CALIFORNIA COASTAL COMMISSION

ADDENDUM

SUBJECT: Agenda Item 12a, Wednesday, August 8, 2012
CDP No. 4-09-013 (Mariposa Land Company)

FIGURE 4

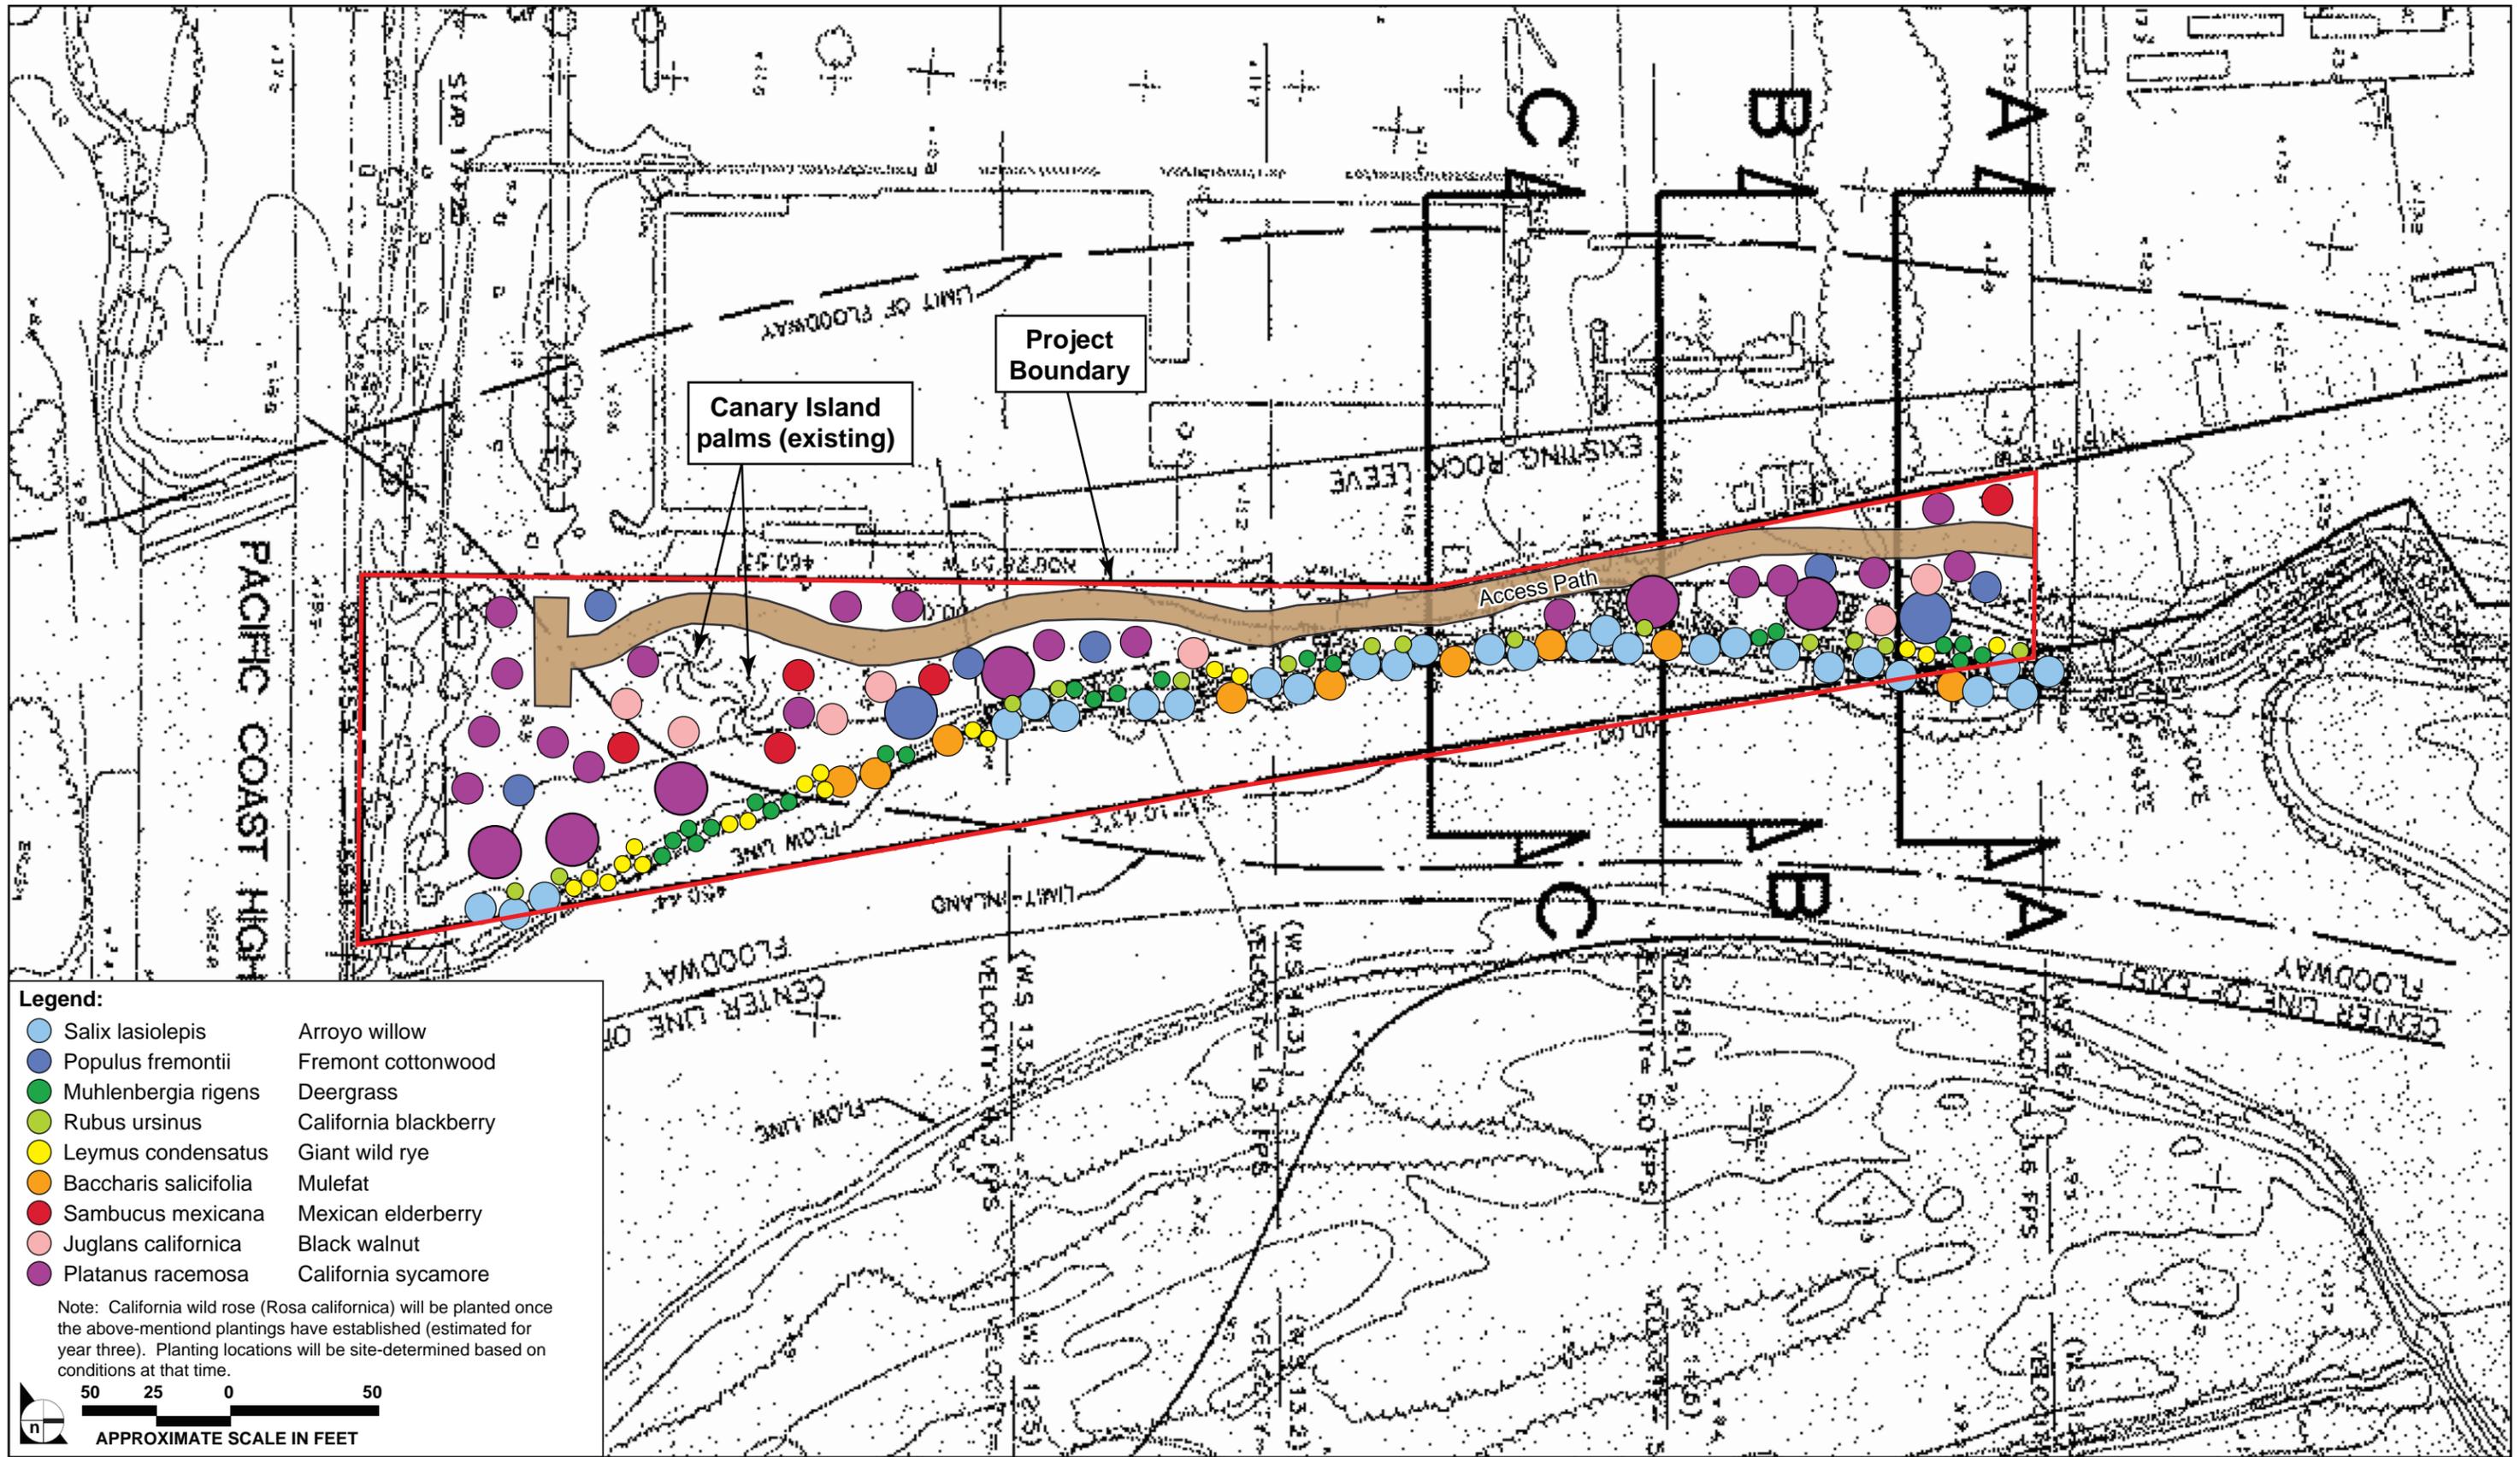
D. Crawford Comment 1: The two existing canary island date palm trees within the restoration area should be removed.

D. Crawford Comment 2: A 5-year monitoring period should be required instead of the proposed 3-year because 5 years is an industry standard and additional time may be needed in this case to ensure success due to the uniqueness of planting in the existing rip-rap.

In response to this comment, Commission staff would note that the two existing mature palm trees in the upland portion of the proposed restoration area are not considered an invasive species and would not inhibit the restoration and biological function of the site. The trees have been there for more than 60 years and may provide some habitat value for birds. Therefore, Commission staff cannot justify requiring that they be removed.

In response to this comment, Commission staff would note that a 3-year monitoring period for the proposed restoration plan has been required in this case pursuant to Special Condition 2 due to site-specific considerations such as the scale of the project and the water-rich environment that will speed plant establishment. Commission staff

Biologist, Dr. Engel, has determined that given the site-specific considerations in this case, it would be possible for the restoration effort to meet the performance standards within the 3-year monitoring period. If not, there is an adaptive management provision in Special Condition 2 that requires follow-up measures be undertaken should the third year monitoring report indicate that the planting is not in conformance with or has failed to meet the performance standards.
